The Alameda County Environmental Health has reviewed SOMA Environmental (SOAM)'s workplan dated November 29, 2004. The workplan recommends drilling cone penetrometer test (CPT) and membrane interface probe (MIP) boreholes to evaluate the geology and number of water-bearing zones as well as horizontal and vertical extent of petroleum hydrocarbons and MtBE.

Figure 3: Locations of proposed CPT/MIP boreholes and monitoring well, and existing monitoring wells and soil borings.

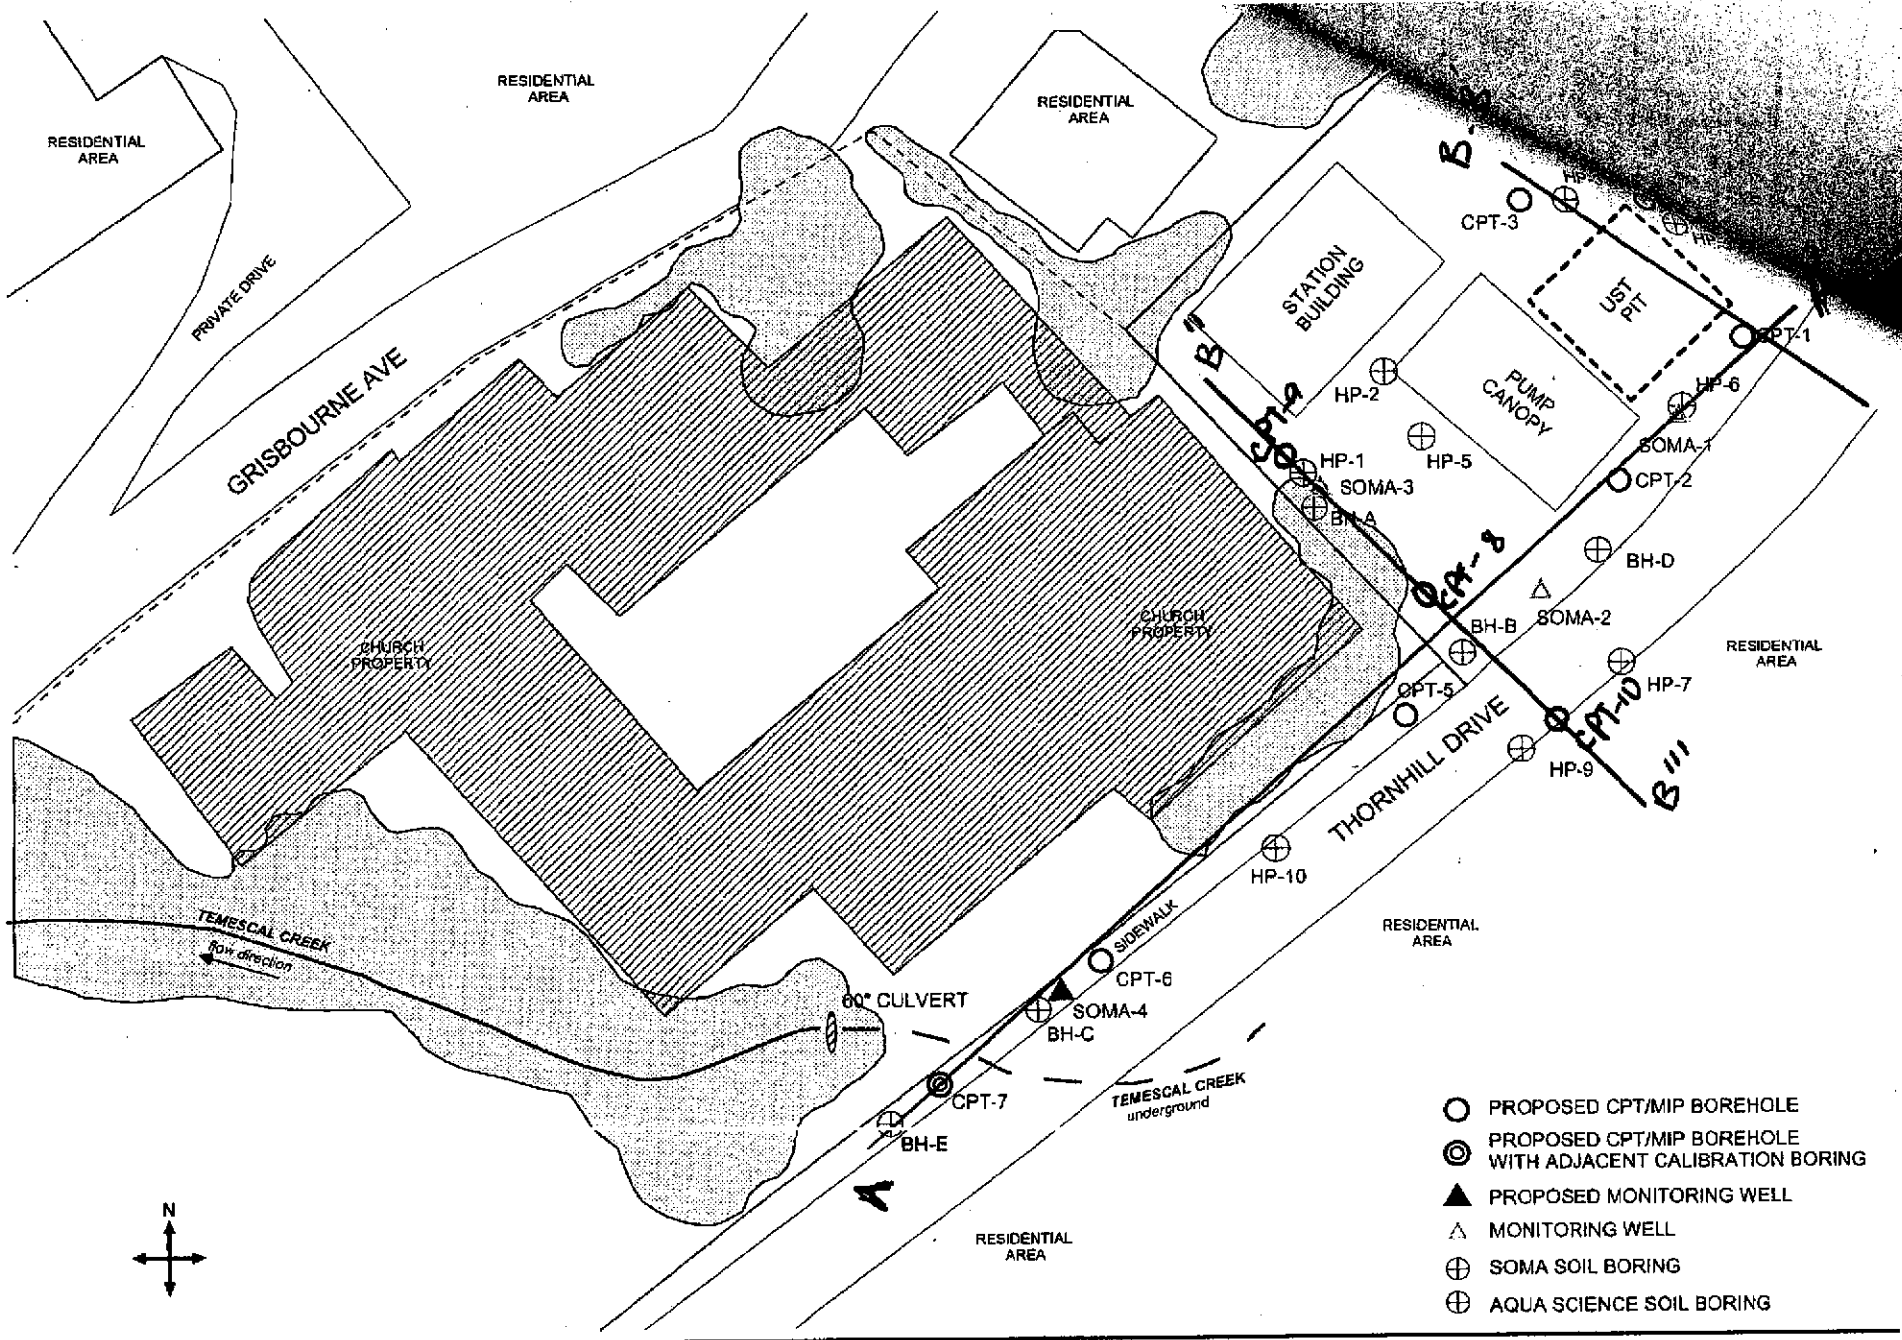
In general, this office concurs with SOMA's workplan. However, additional CPT/MIP boreholes need to be drilled in order to better understand the geology and extent of soil and groundwater contamination. Upon completion of the proposed CPT/MIP study, we recommend longitudinal and transverse geologic cross sections to be prepared for better understanding of the site's conceptual model. We recommend one longitudinal and two transverse cross sections to be drawn. The longitudinal cross-section A-A' may utilize the proposed CPT-1, CPT-2, SOMA-2, CPT-5, CPT-6 and CPT-7 results. The two transverse cross-sections at two locations perpendicular to the A-A' cross section will further define the stratigraphy of the subsurface materials.

Cross-section B-B' may utilize CPT-1, HP-4, CPT-4 HP-3 and CPT-3, while the cross-section B''-B''' may utilize CPT-10, SOMA-2, CPT-8, SOMA-3 and CPT-9.

The locations of the additional CPTs as well as the recommended cross sections are presented in the attached figures.

Figure 3: Locations of proposed CPT/MIP boreholes and monitoring well, and existing monitoring wells and soil borings.

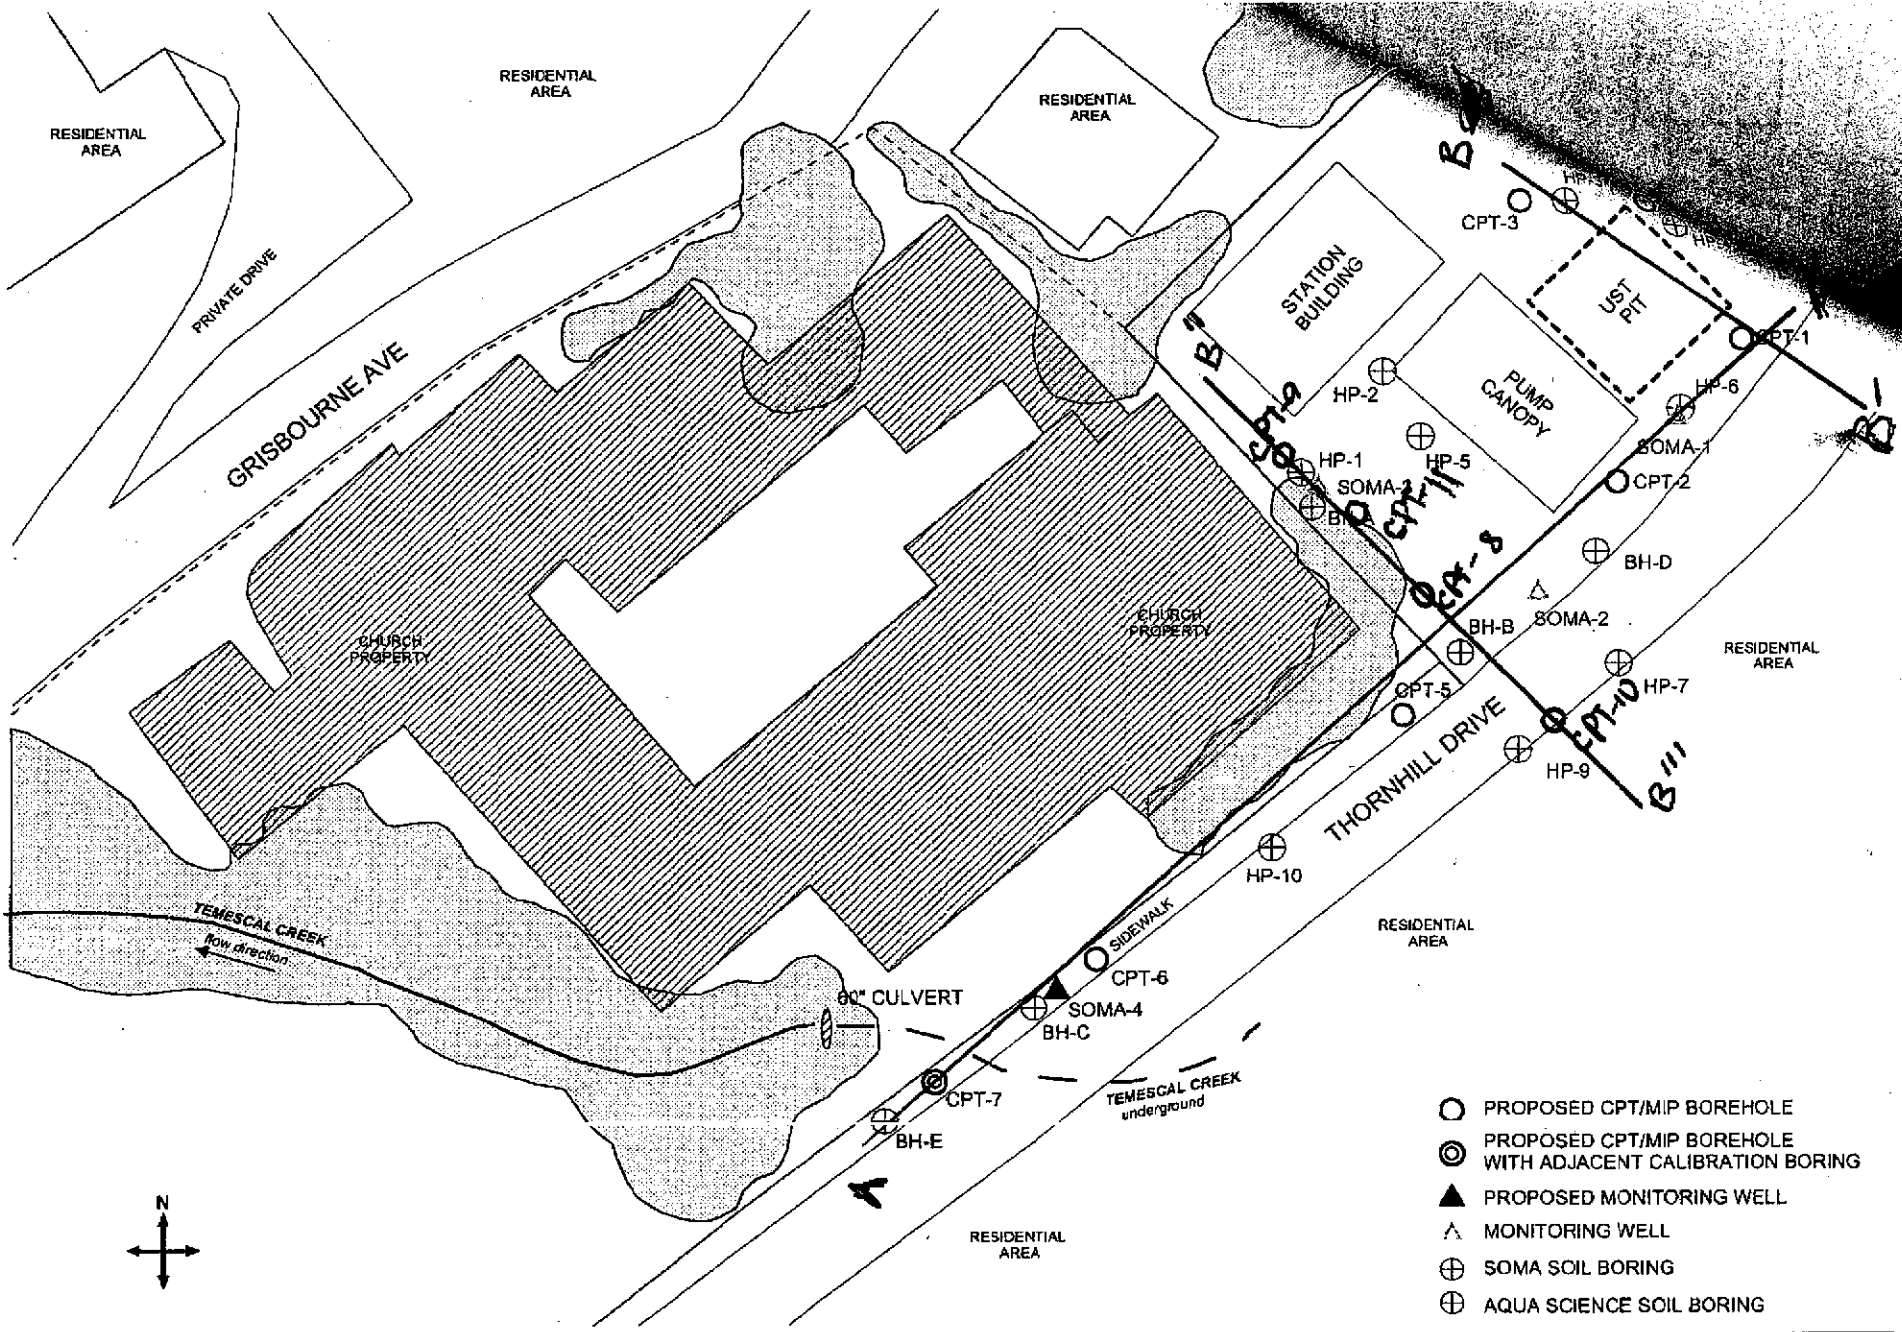
*Additional CPT is proposed between
 CPT - 8 and CPT-9*

In general, this office concurs with SOMA's workplan. However, additional CPT/MIP boreholes need to be drilled in order to better understand the geology and extent of soil and groundwater contamination. Upon completion of the proposed CPT/MIP study, we recommend longitudinal and transverse geologic cross sections to be prepared for better understanding of the site's conceptual model. We recommend one longitudinal and two transverse cross sections to be drawn. The longitudinal cross-section A-A' may utilize the proposed CPT-1, CPT-2, SOMA-2, CPT-5, CPT-6 and CPT-7 results. The two transverse cross-sections at two locations perpendicular to the A-A' cross section will further define the stratigraphy of the subsurface materials.

Cross-section B-B' may utilize CPT-1, HP-4, CPT-4 HP-3 and CPT-3, while the cross-section B''-B''' may utilize CPT-10, SOMA-2, CPT-8, SOMA-3 and CPT-9.

The locations of the additional CPTs as well as the recommended cross sections are presented in the attached figures.
